Southern Nuclear Operating Company  
Vogtle Electric Generating Plant Unit 3  
Preliminary Amendment Request (PAR): Containment Internal Structural Module  
Shear Stud Size and Spacing (PAR-12-001)

**Containment Internal Structural Module Shear Stud Size and Spacing**

Figure 3.8.3-8 (Sheet 1 of 3)

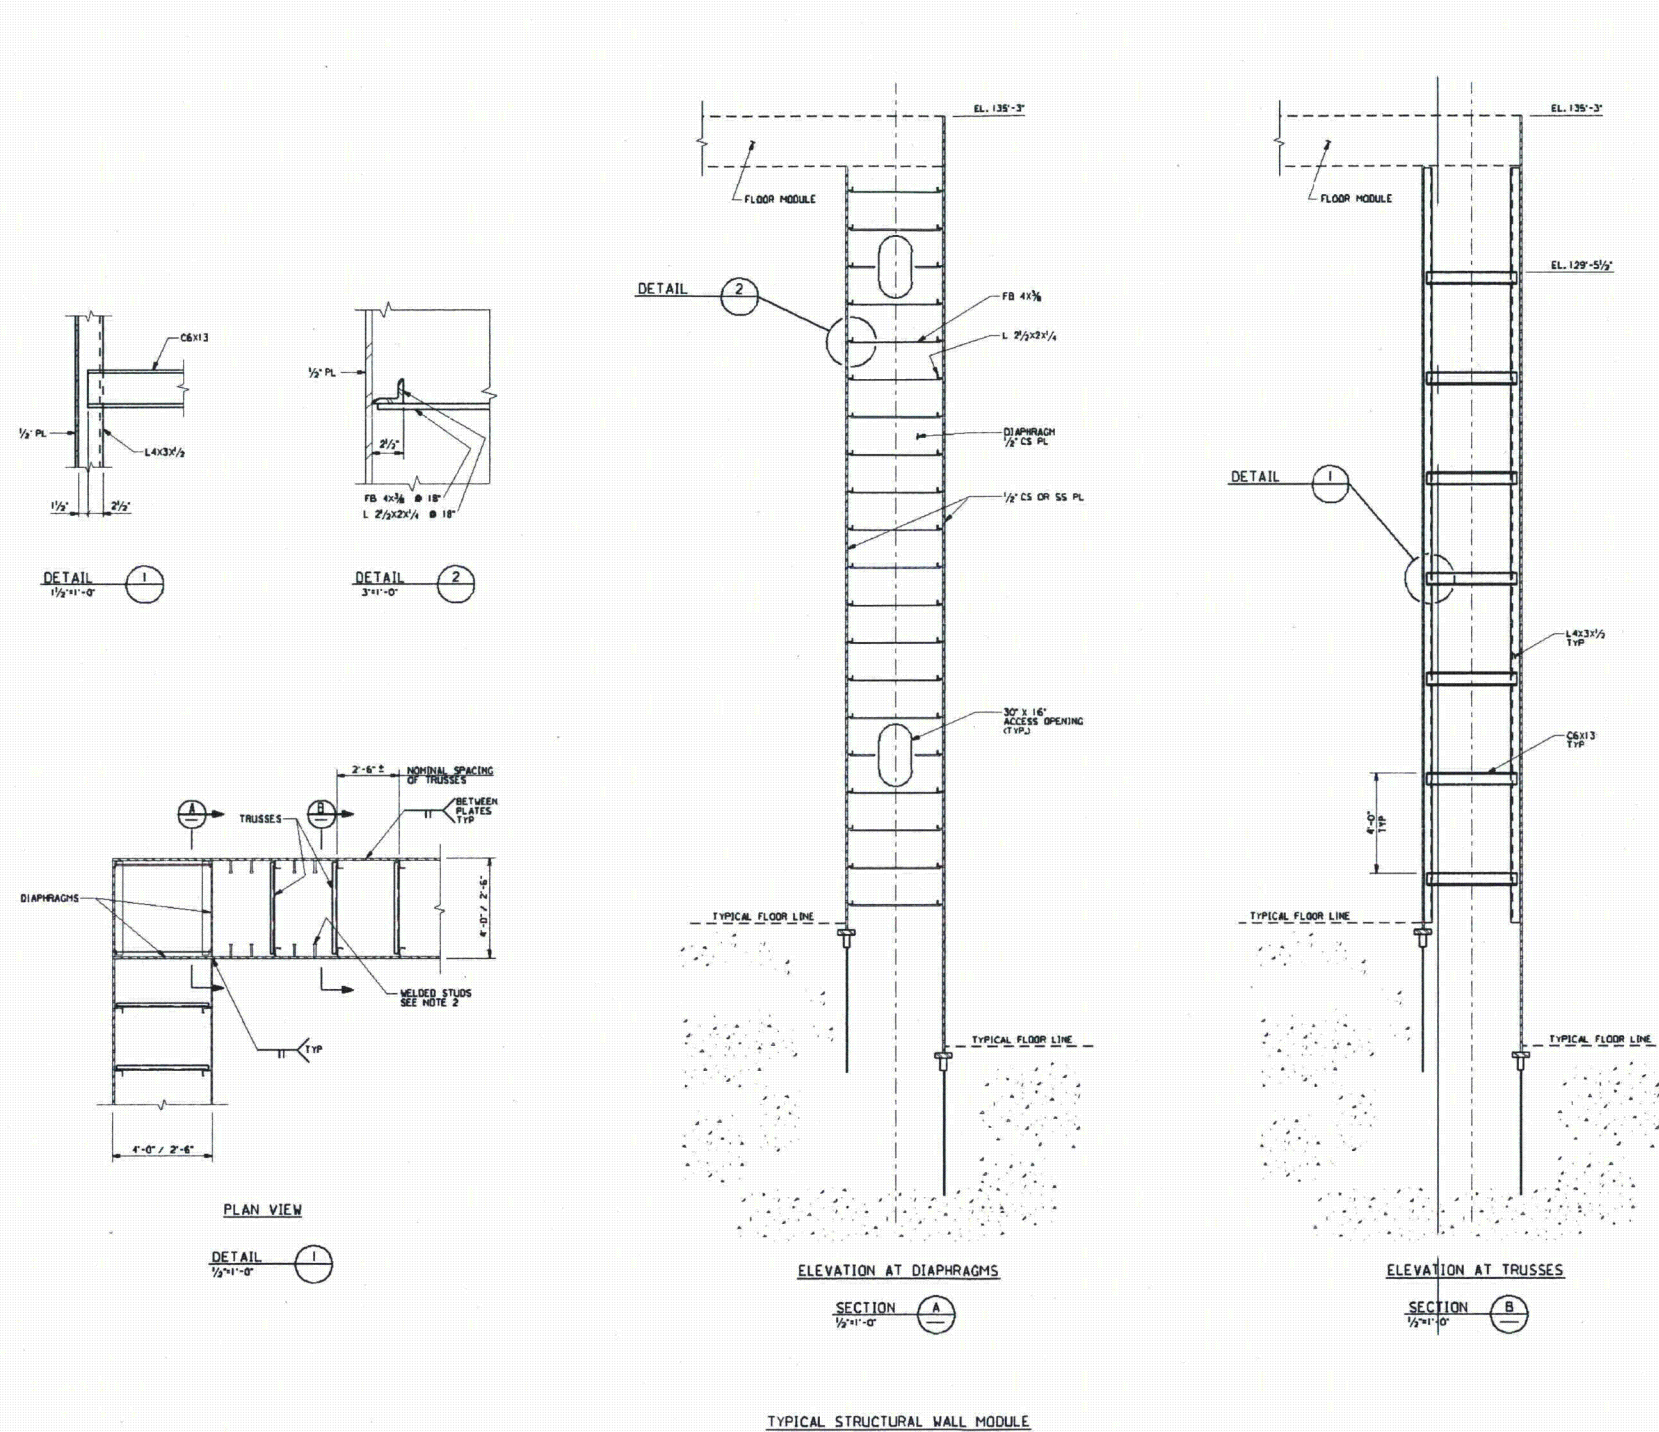
The proposed changes would amend Combined Licenses Nos. NPF-91 and NPF-92 for Vogtle Electric Generating Plant Units 3 and 4, respectively, in regard to the containment internal structural module stud size and spacing by increasing the carbon steel vertical stud spacing, decreasing the stainless steel stud diameter, and decreasing the stainless steel vertical and horizontal stud spacing in accordance with the design basis.

The departure from Tier 2\* information involves changes to Sheet 1 of plant-specific DCD Figure 3.8.3-8. An evaluation to determine whether or not a significant hazards consideration is involved with the proposed amendment was completed by focusing on the three standards set forth in 10 CFR 50.92, "Issuance of amendment," as discussed below:

The design function of the containment modules is to support the reactor coolant system components and related piping systems and equipment. The design function of the shear studs is to transfer loads into the concrete of the containment modules. The proposed change corrects a drawing note regarding shear stud size and spacing for structural wall modules to be consistent with the underlying design basis calculations, which are more conservative. The thickness, geometry, and strength of the structures are not altered. The material and thickness of the steel plates are not altered. The properties of the concrete included in the containment internal structures are not altered. As a result, the design function of the containment modules is not adversely affected by the proposed change. There is no change to plant systems or the response of systems to postulated accident conditions. There is no change to the predicted radioactive releases due to normal operation or postulated accident conditions. The plant response to previously evaluated accidents or external events is not adversely affected, nor does the change described create any new accident precursors. Therefore, there is no significant increase in the probability or consequences of an accident previously evaluated.
